# FREDERICK COUNTY PLANNING COMMISSION September 12, 2012

TITLE: Supply to Barren Residential Cluster, Lots

FILE NUMBER: S-871, AP 12438

REQUEST: Residential Cluster Concept Plan

Exhibit #1: Supply to Barren Residential Cluster Concept Rendering

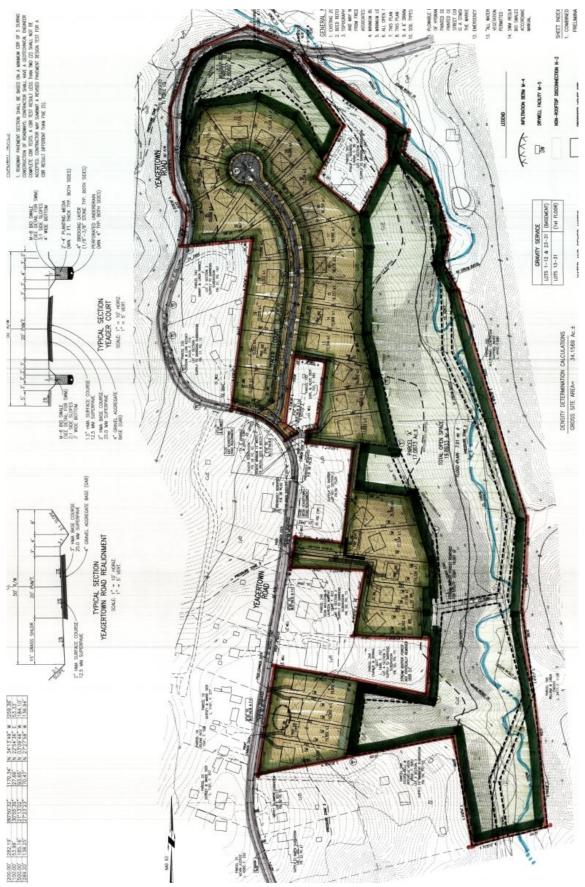
The cluster plan illustrates a variation in lot size without increasing the overall density. The lots range in size from 15,000 square feet to 31,709 square feet, with the average lot size being 18,060 square feet. Roughly 19.99 acres of the overall site will be owned and maintained as open space by the homeowners association. The majority of the proposed open space consists of floodplain, steep slopes, heavily forested areas, and waterbody buffers.

The Applicant is seeking approval of the permitted modifications in lot area; none of the proposed 31 lots meet the typical 40,000 square foot lot size requirement for the R-1 zoning district. The lots will meet all other R-1 standards. Public water and sewer will service the site.

After deducting the flooding soils and the right of way dedication for Yeagertown Road, the net developable area is 31.056 acres (1,352,799 square feet), which permits a density of 31 lots under the standard R-1 dimensional requirements. The Applicant is proposing 31 lots which will not exceed the density permitted by the R1 zoning district for single family residential lots on this site.

Lots 1-9 will take access directly off of Yeagertown Road, classified as a rural local street. Lots 1-2 and 3-4 will each share a common entrance off of Yeagertown Road. Lots 5-9 are proposed as panhandle lots connecting to Yeagertown Road via a common driveway. Lots 10, 11 and the existing Parcel 142 will share a common driveway which will access Yeagertown Road. Lots 12-31 will access a proposed cul-de-sac (Yeager Court) that will be constructed with the typical 20-foot wide paved surface and dedicated to the County for public use. Intersection sight distance on Yeagertown Road has been found to be adequate by the applicant's engineer. Off-site, Yeagertown Road is a publically maintained road with a 16 - 20 foot wide paved surface.

The Subdivision Regulations (1-16-219.c.3) do not allow more than 4 lots panhandle lots. Lots 5-12 are panhandle lots. The Applicant is proposing that Lot 9 will have a panhandle connection to the common driveway, which serves Lots 10 and 11, as well as existing parcel 142. The actual access for Lot 9 is proposed to be located on the common driveway for Lots 5-9.

Staff has no objection to the proposed cul-de-sac. The Planning Commission will consider final approval of the new public street during their review of the Preliminary Plan application, which will follow concept plan approval. The FCPC will have to approve a modification for any proposed panhandle lots at the time of Preliminary Plan approval.

Staff has no objection to conditional approval of the concept plan.

- 1. The Applicant shall comply with all Staff and agency comments through the completion of the plan.
- 2. The approval of this plan does not guarantee approval of future preliminary plans or final plats. All future applications shall be reviewed and approved in the normal manner and in accordance with all applicable regulations.
